December 12, 2017

RE: **PLUS review 2017-10-01**  
**MEDICAL OFFICE BUILDING**  
Milford, Delaware  
2014092.08

Please find below our point by point response to your comments received November 28, 2017. For ease of review, **please** find our responses below in a different font and color.

Figure 1: NRCS soil survey mapping update in the immediate vicinity of the proposed construction

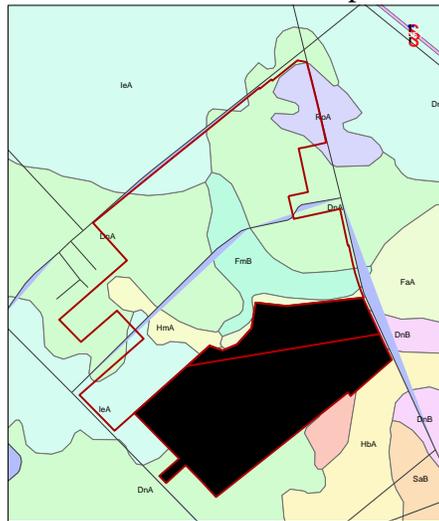
- Based on NRCS soil survey mapping update, the primary soil mapping unit of concern mapped in this parcel is Fallsington (FaA). Fallsington is a poorly-drained wetland associated hydric soil that is considered to have severe limitations, considered unsuitable for development (Figure 1).

**Response:** *The soil comments are noted.*

Figure 2: SWMP mapping in the immediate vicinity of the proposed construction

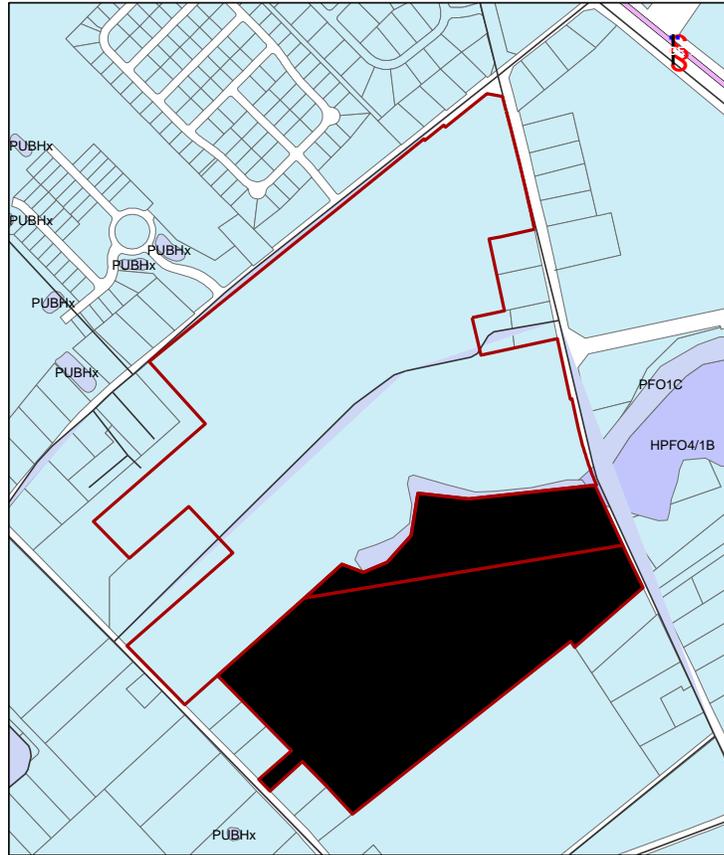
- Establish a vegetated buffer of at least 100 feet from the adjoining wetlands and waterbodies, including all ditches and ponds, and all non-tidal (USACE approved wetlands) and tidal wetlands (State-approved wetlands). Based on a review of existing buffer research, an adequately-sized buffer that effectively protects wetlands and streams, in most circumstances, is about 100 feet in width (Castelle, A. J., A. W. Johnson and C. Conolly. 1994. Wetland and Stream Buffer Requirements – A Review. J. Environ. Qual. 23: 878-882.). The Watershed Assessment Section recommends that the applicant maintain/establish the 100-foot buffer, using existing or planted in native vegetation.

**Response:** *The TMDL & water quality comments are noted.*
